H. B. ROBINSON STEAM GENERATING PLANT UNIT NO. 2

AMENDMENT TO FACILITY OPERATING LICENSE

Amendment No. 9
License No. DPR-23

CHANGE NO. 34 TO APPENDIX A TECHNICAL SPECIFICATIONS

Control Group Insertion Limits for
Three Loop or Two Loop Operation

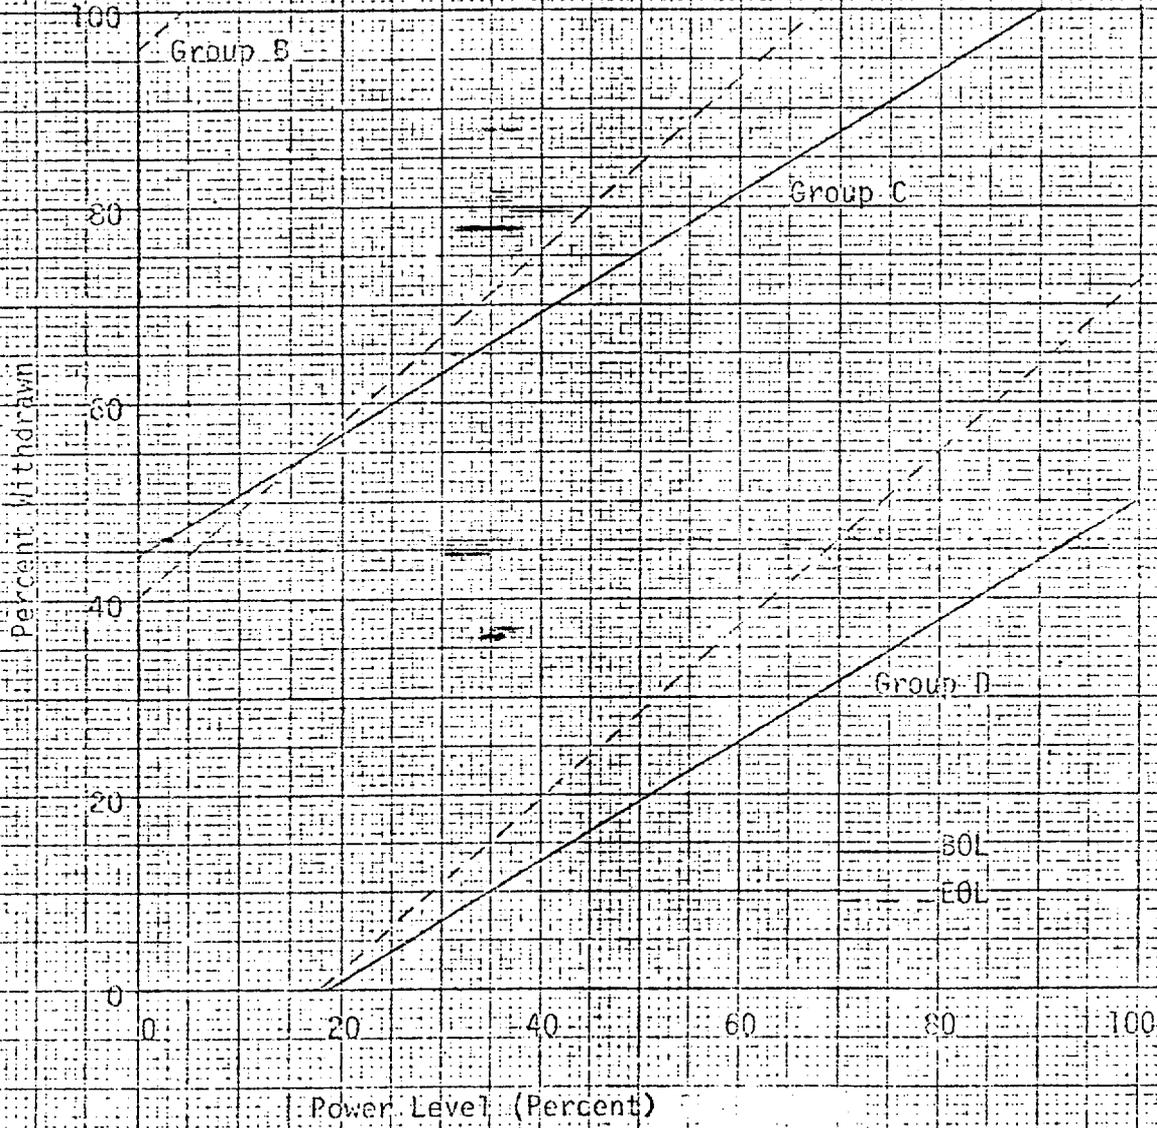
- 3.10.1.3 When the reactor is critical, except for physics tests and full length control rod exercises, the control rods shall be no further inserted than the limits shown by the solid lines on Figure 3.10-1 for 3 loop or 2 loop operation.

- 3.10.1.4 After 50% of the second and subsequent cycles as defined by burnup, the limits shall be adjusted as a linear function of burnup toward the end-of-core life values as shown by the dotted lines on Figure 3.10-1.
